Independent Review of the Bowdens  
Silver Pty Limited Surface Water  
Assessment – Updated  
*(Shireen Baguley, March 2022)*

Updated May 2022

Independent Review of the  
Bowdens Silver Pty Limited  
Surface Water Assessment – Updated  
(WRM Water + Environment Pty Ltd  
February 2022)

Figure 1 Average monthly rainfall data presented in Bowdens surface water assessment

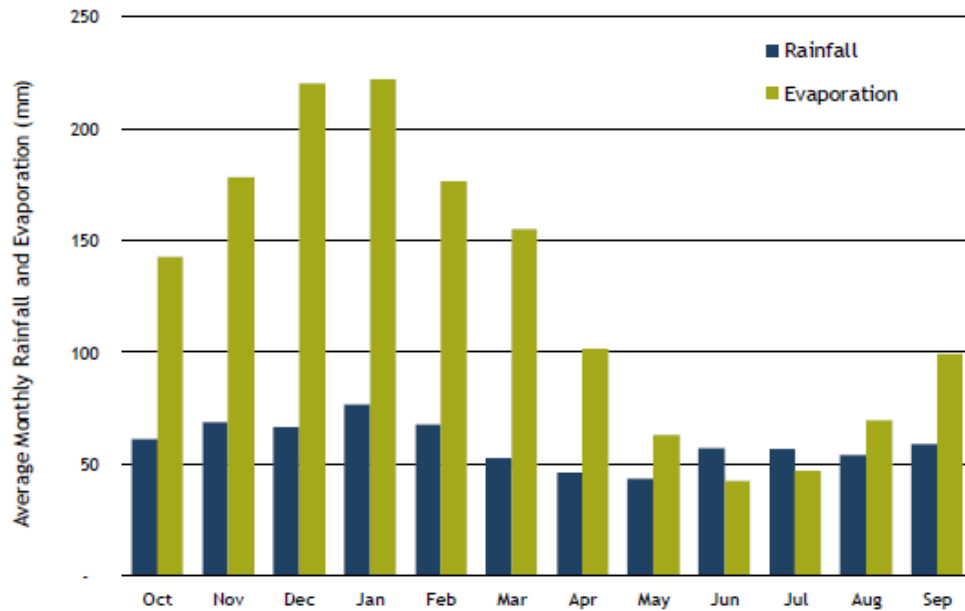
The Bowdens surface water assessment data appears to show a monthly average that exceeds 75mm over summer. This is incorrect, as evidenced by the rainfall data from Mudgee (26km west of the mine site), Rylstone (22km south of the mine site) and Lue Station.

Many of the other months are also too high when compared to Mudgee, Rylstone and Lue rainfall statistics. The data should be reviewed and revised down so as to not incorrectly inflate the amount

of rainfall which the region actually receives. The data for the Bowdens site needs to be presented numerically, so they can be clearly understood.

*Figure 5 Annual monthly rainfall data presented in Bowdens surface water assessment*

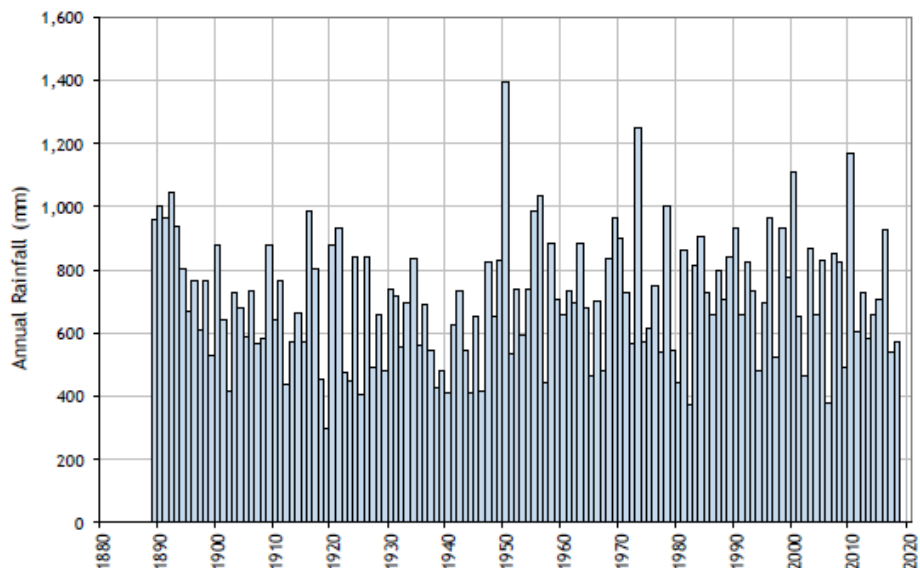
The number of very low rainfall years is clearly not reflected in the Bowdens' surface water assessment annual rainfall data, which has only three years of less than 400mm. This in part seems to be a deliberate attempt to distort the data, as it has excluded 1888 and 2019, both of which are very dry years. Actual long term rainfall data recorded by landholders in the region show there has

been nine (9) years where rainfall of less than 400mm has been recorded between 1887 and 2021; and 23 years where rainfall of less than 500mm has been recorded in this period.

Figure 13 Potential groundwater induced leakage and interception due to mining<sup>11</sup>

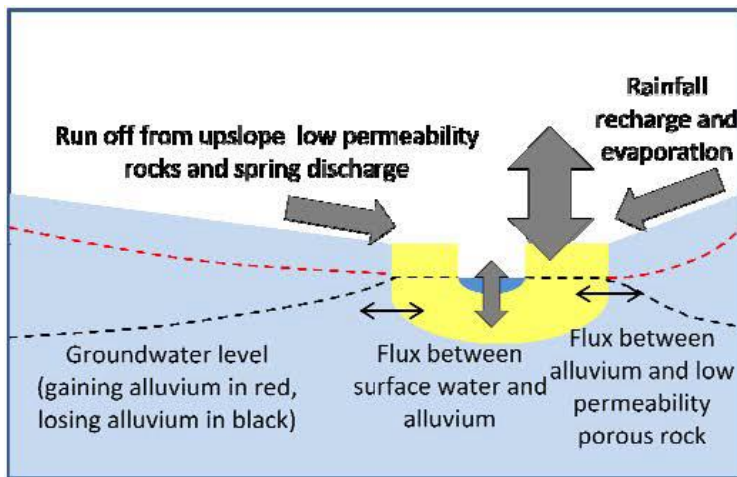
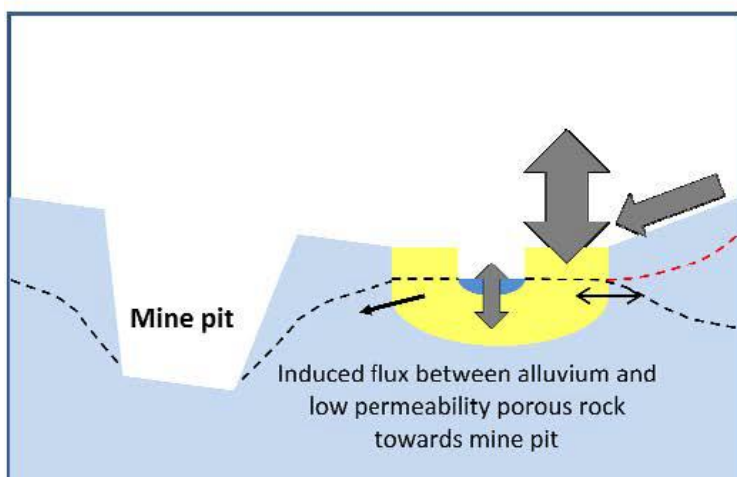
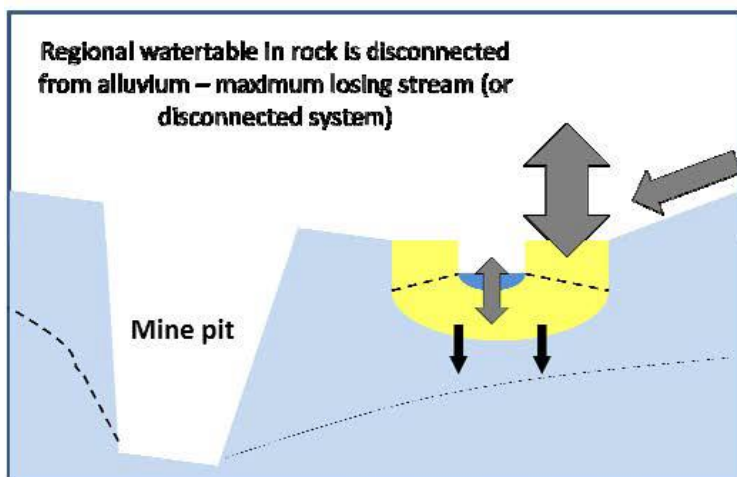
Mining drawdown and depressurisation of groundwater can change the natural groundwater flow pattern and discharge location. Figure 13 compares potential changes in groundwater flow between porous rock, alluvium and surface streams - pre-mining and during mining (Imrie, 2019; Ross and Webb, 2015).

Numerical groundwater modelling has been undertaken for the proposed Bowdens' mining operations, however, as illustrated in the above discussion, to be of any value, the outputs of modelling methods are dependent on the availability of accurate and long term input. There is a paucity of data available in this instance, being limited to one off water levels and an average of measured groundwater levels measured for just over six years at the Bowdens' site<sup>10</sup>. Given the paucity of data, exacerbated by a high level of uncertainty, there cannot be any confidence in the predictions derived from the modelling which has been presented nor the impacts to springs and waterways assessed using the modelling.

Figure 15 Regional Biophysical Strategic Agricultural Land (BSAL)

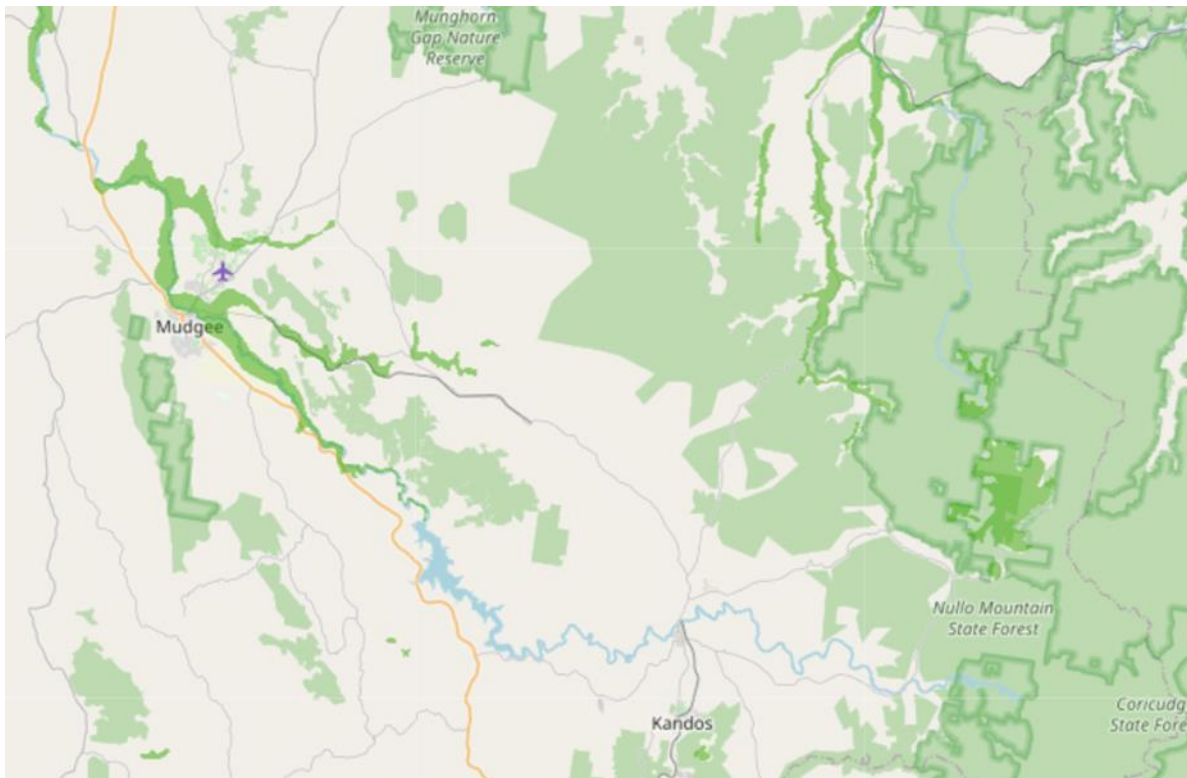
Downstream of the proposed mine site, there is BSAL present (Figure 15). The surface water assessment has not considered the impacts of using water from within Bowdens' holdings on this land.

As has been demonstrated in the analysis in this paper, the catchment in which the mine site is proposed has a high variability in rainfall and frequently experiences dry years. The water that supports the BSAL land moves through the upstream catchment and then is available to support agriculture in the mapped areas. Any mining within the supporting catchments threatens the water resource in the BSAL areas. The proposed mine will interrupt both groundwater and surface water flows, and as such, the BSAL area is at risk of losing the critical water which underpins its inherent value.
